**SECTION 00 90 03
BIDDING AND CONTRACT REQUIREMENTS
ADDENDUM NUMBER 3**

Re: ADDENDUM NUMBER (3) TO THE BIDDING DOCUMENTS FOR

**McHenry County College
University Center at MCC**
Architect's Project Number: 22-050

CLASSROOMS A/V SCHEMATIC DIAGRAM
 NO SCALE

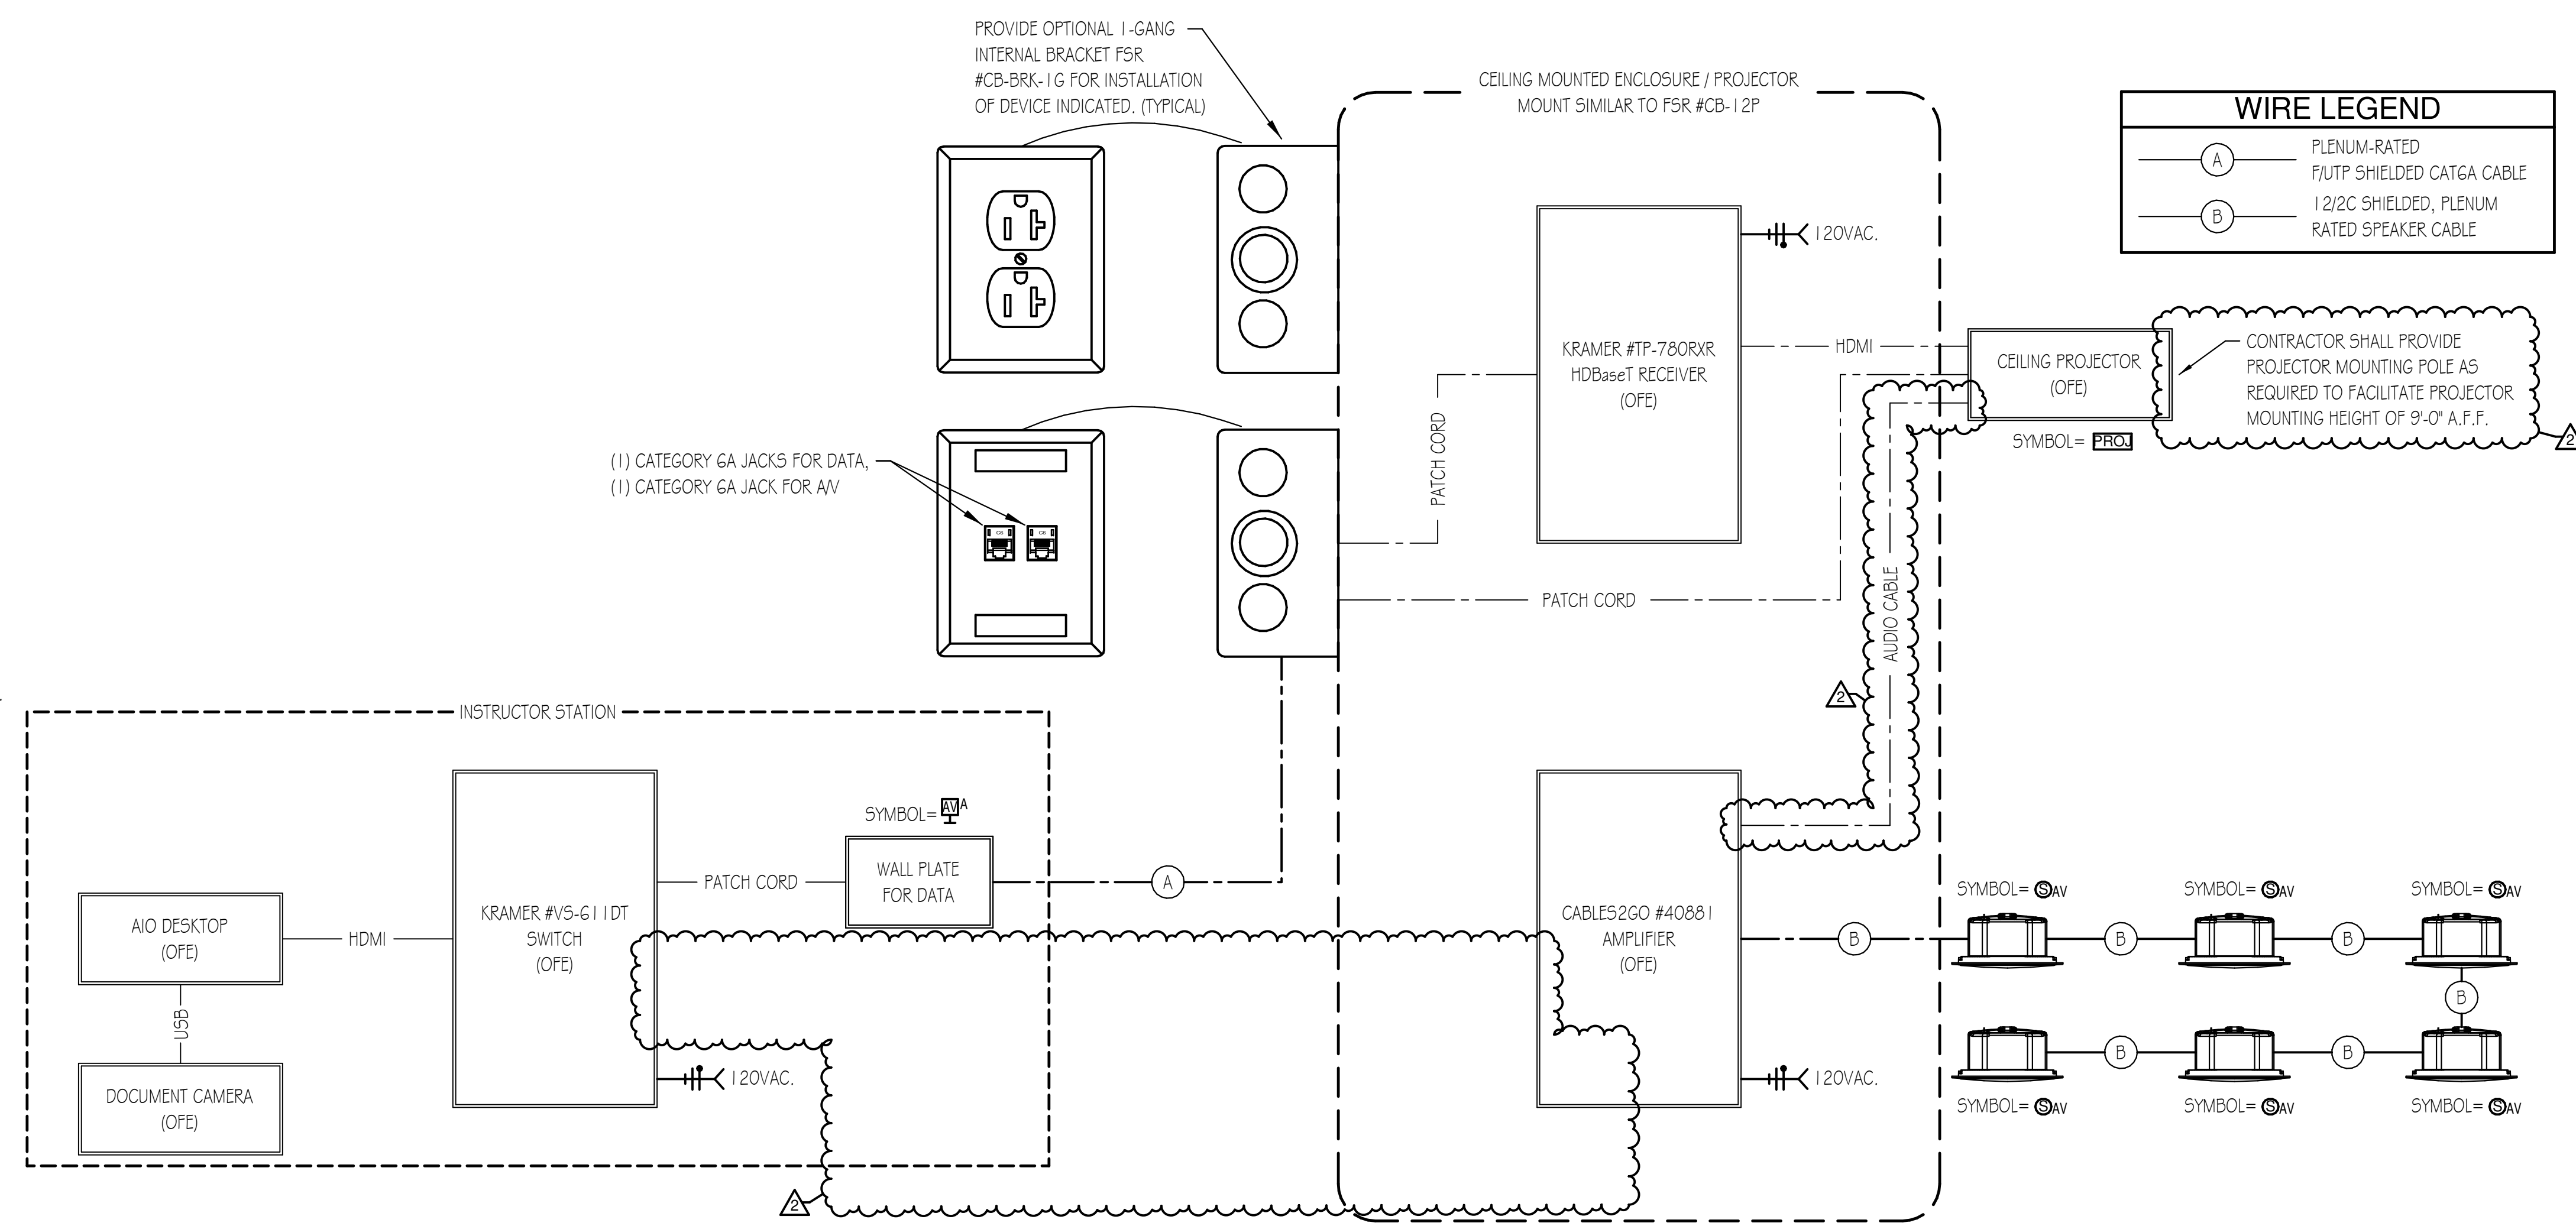
5. E6.00
 - A. **REVISE** luminaire types "F3A" and "F7".
6. E7.20
 - A. **REVISE** 'ACCESS CONTROL / SECURITY DEVICE DETAIL'.
7. E7.30
 - A. **REVISE** 'CLASSROOMS A/V SCHEMATIC DIAGRAM'.

SHEET NUMBER:
E7.40

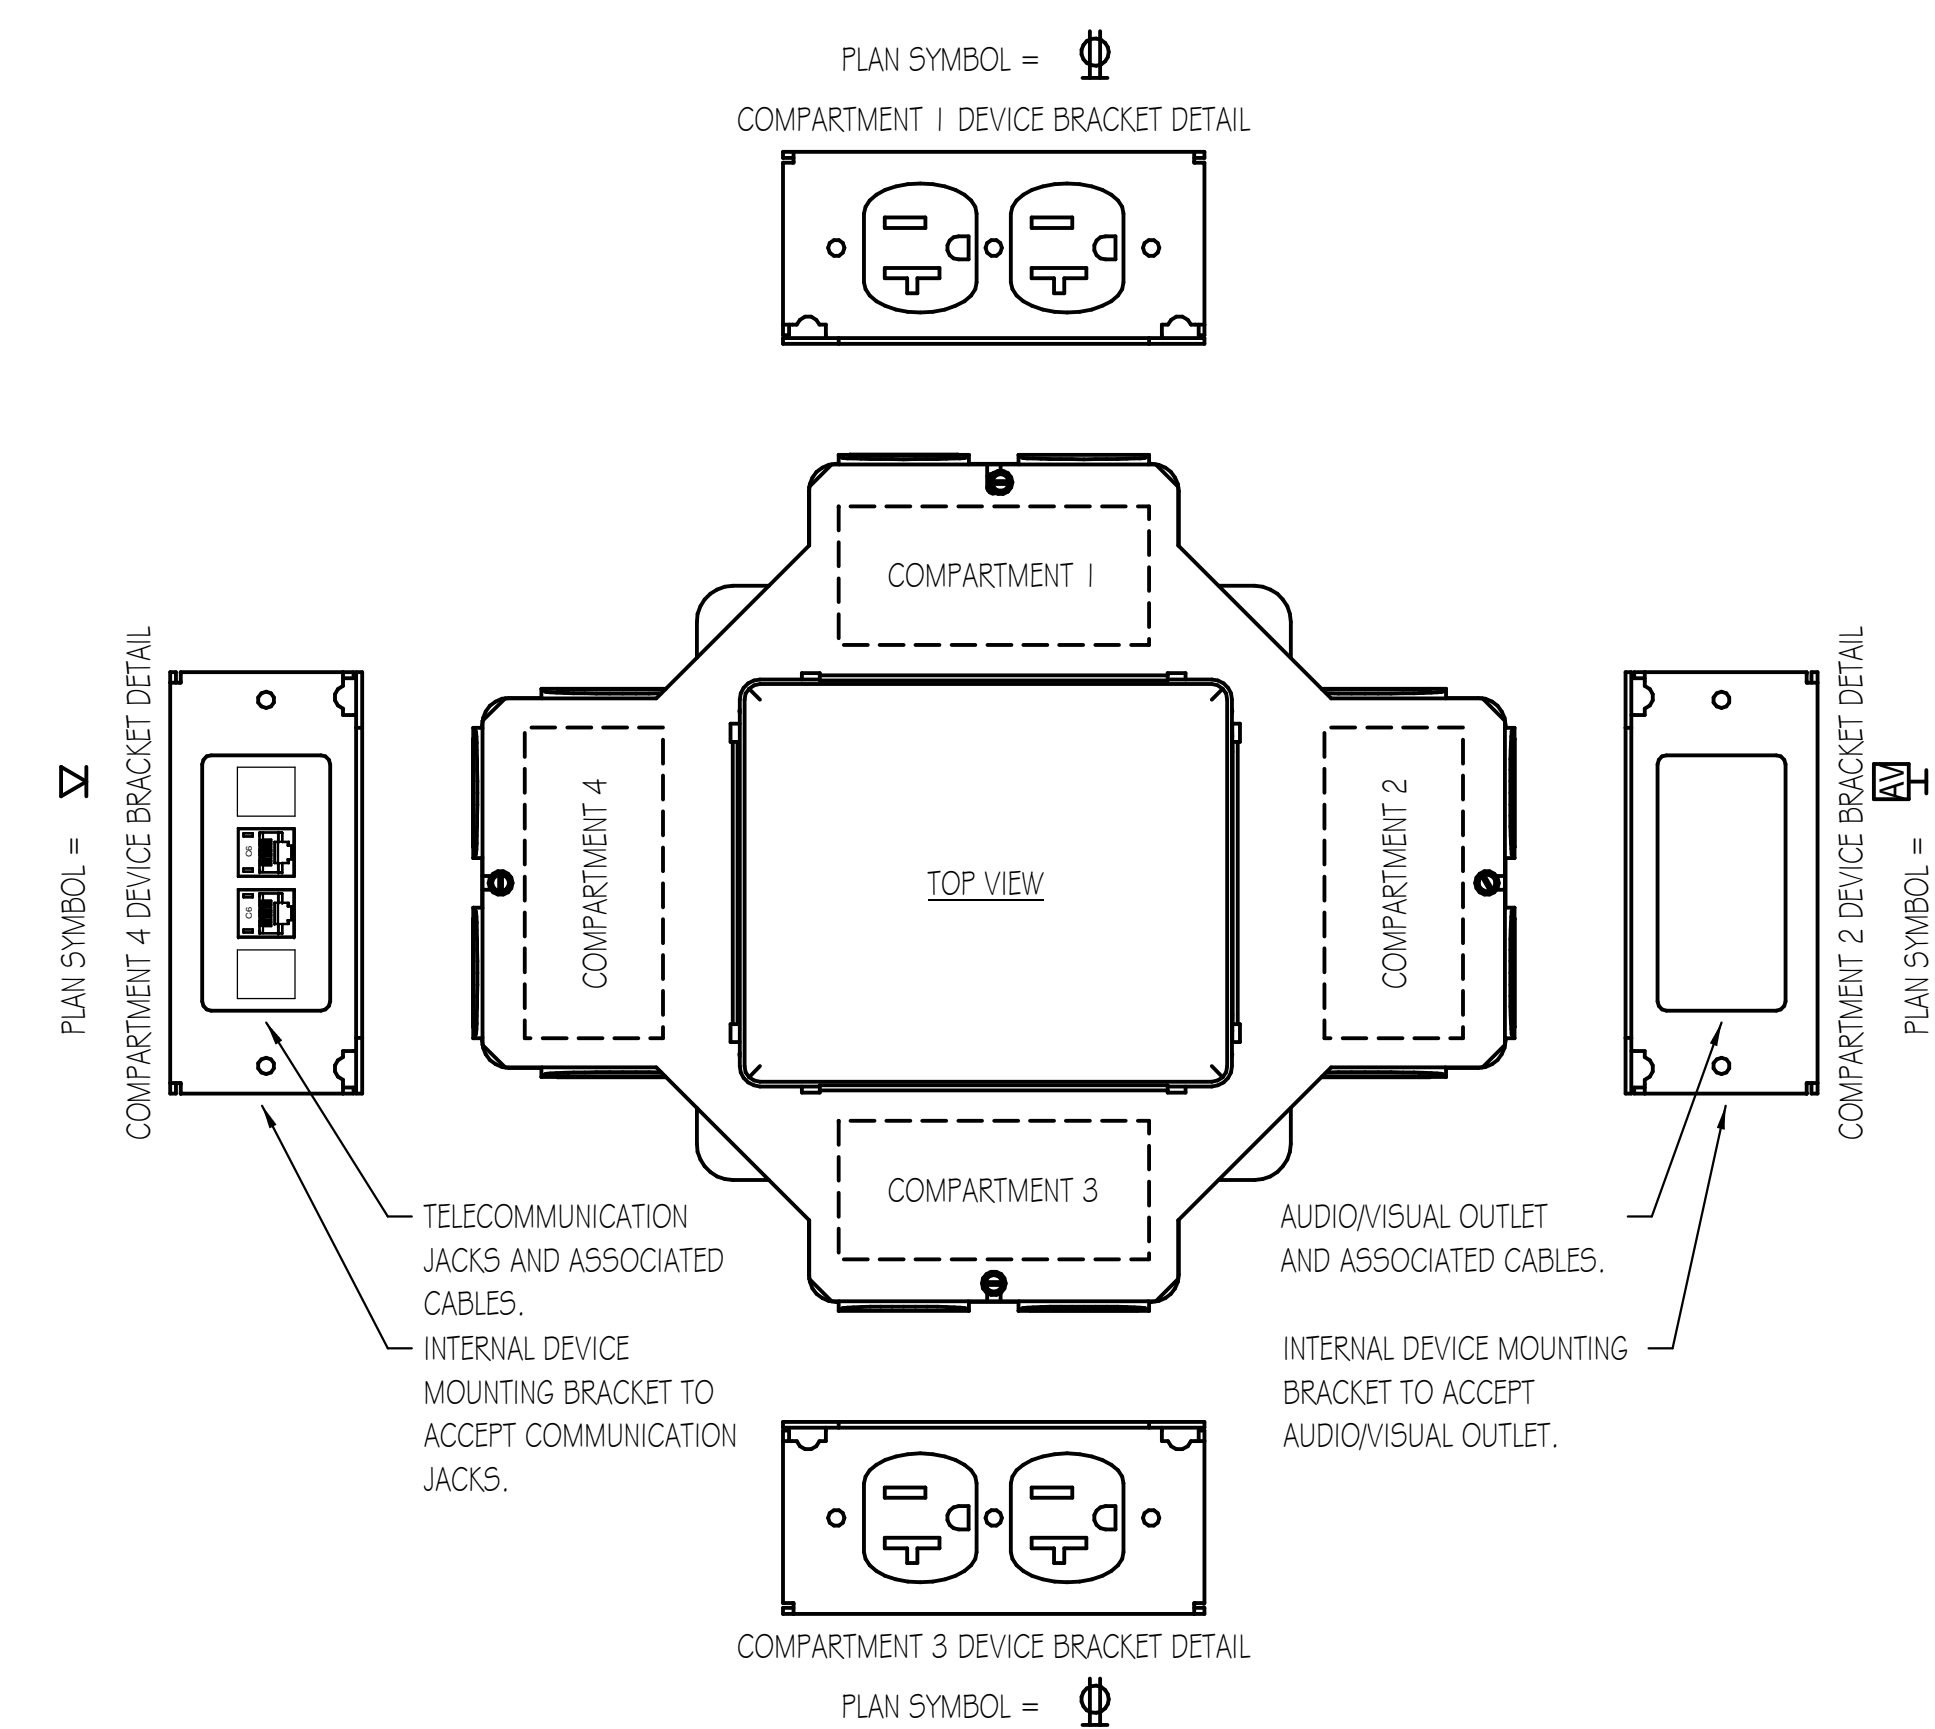
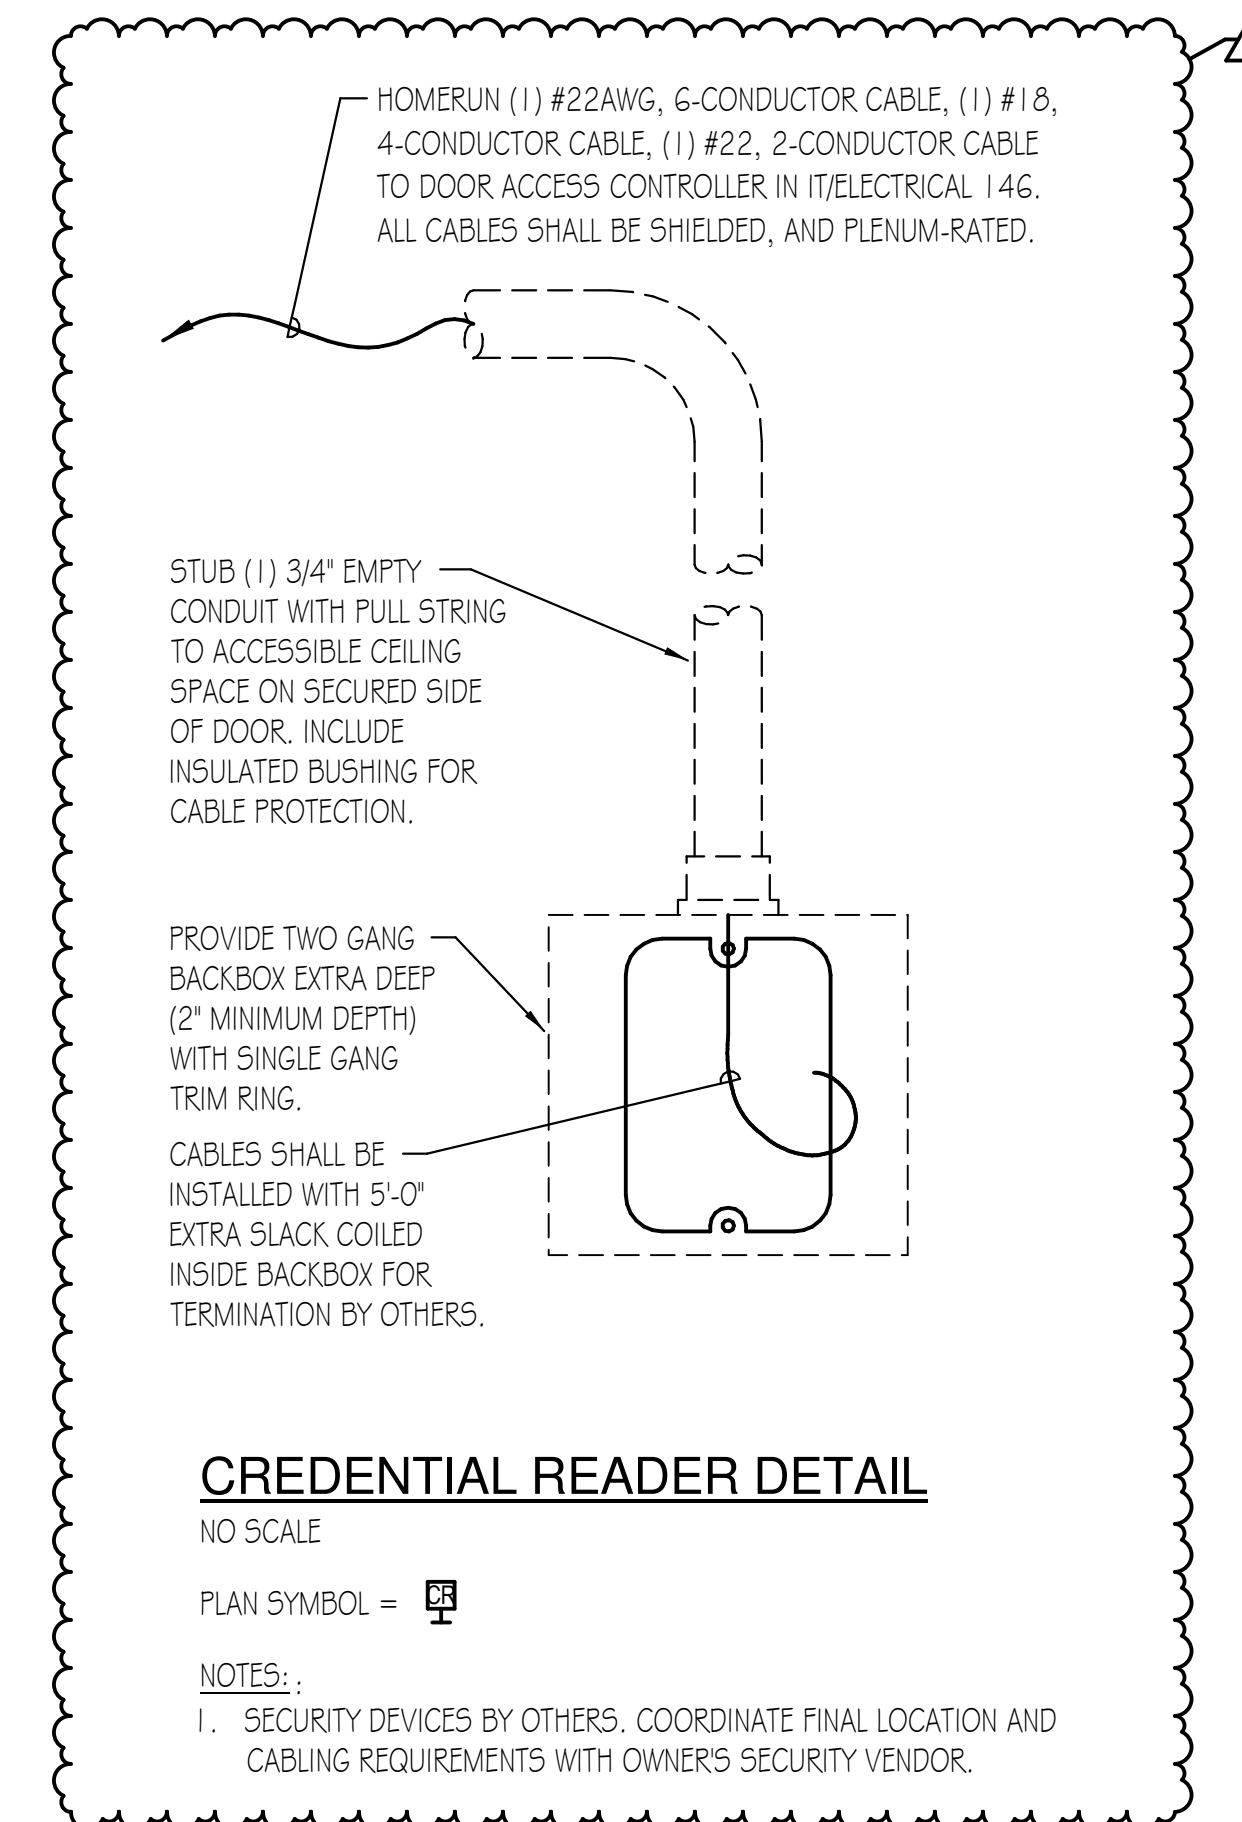
8. E7.40
 - A. **ADD** 'CREDENTIAL READER DETAIL'.
